Number: TAB 07-003

Notice: GS3055-I Trouble Supervision

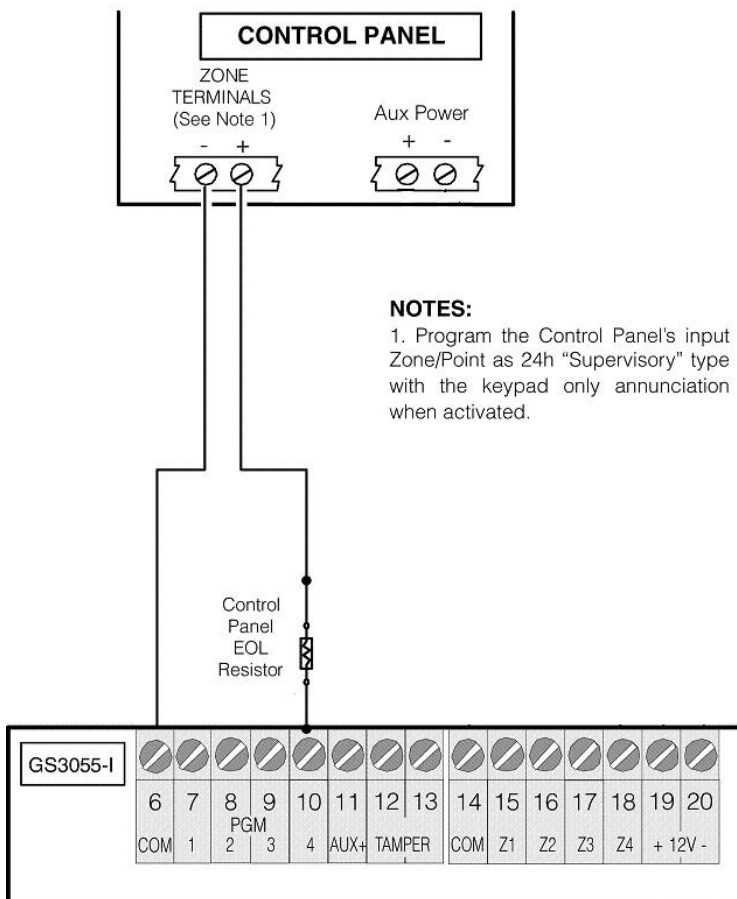
To ensure proper notification of troubles on the GS3055-I, it is strongly recommended that output 4 on the GS3055-I is connected to a zone on the control panel. The zone should be programmed as a 24 Hour Supervisory which will annunciate at the keypad when a GS3055-I trouble is present.

Detailed information on wiring output 4 to the zone is contained in the GS3055-I Installation Manual in the Wiring Diagrams section and is reproduced below.
